Well Name: AMAX 24 FEDERAL	Well Location: T23S / R31E / SEC 24 / NWNW / 32.2944477 / -103.7368121	County or Parish/State: EDDY / NM
Well Number: 3	Type of Well: OIL WELL	Allottee or Tribe Name:
Lease Number: NMNM40655	Unit or CA Name:	Unit or CA Number:
US Well Number: 3001525407	Operator: OXY USA INCORPORATED

Notice of Intent

Type of Submission: Notice of Intent	Type of Action: Plug and Abandonment
Date Sundry Submitted: 07/03/2024	Time Sundry Submitted: 12:34
Date proposed operation will begin: 08/05/2024

NOI TO PERMANENTLY ABANDON THIS WELL VIA CEMENT PLUGGING.

Current Wellbore
FEDERAL 24 #003

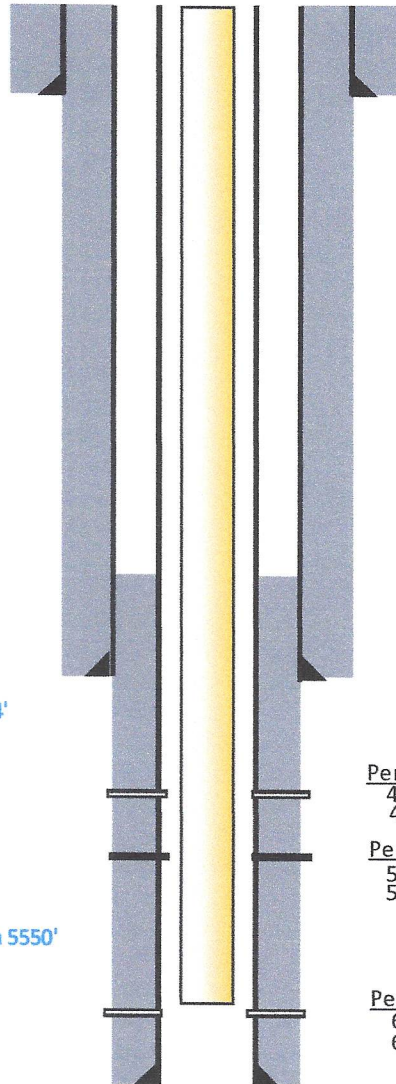
1. ROOH WITH CURRENT 2 3/8" TUBING AND BHA
2. SET CIBP AT 6043' WITH WORK STRING. PRESSURE TEST CIBP.
3. SPOT ~~185~~ SX CL C CMT FROM 6043' TO 3550'. WOC AND TAG. 170 SXS
4. PERF AND CIRCULATE 1052 SX CL C CMT FROM 3530' TO SURFACE.
5. VERIFY CMT TO SURFACE. WOC AND TAG.

* Run CBL from 4531' to surface.

Proposed Wellbore
FEDERAL 24 #003

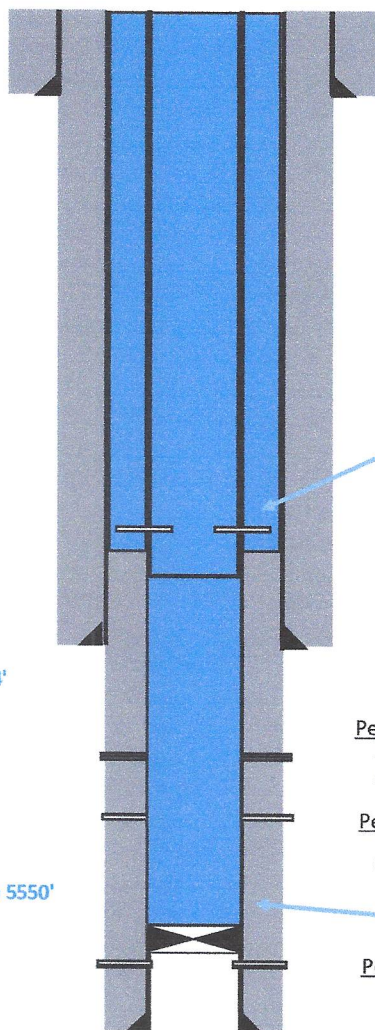
SET CIBP @ 6043' AND SPOT
185 SX CMT FROM 6043' TO 3550' 170 SXS
WOC AND TAG

* Run CBL from 4531' to surface.
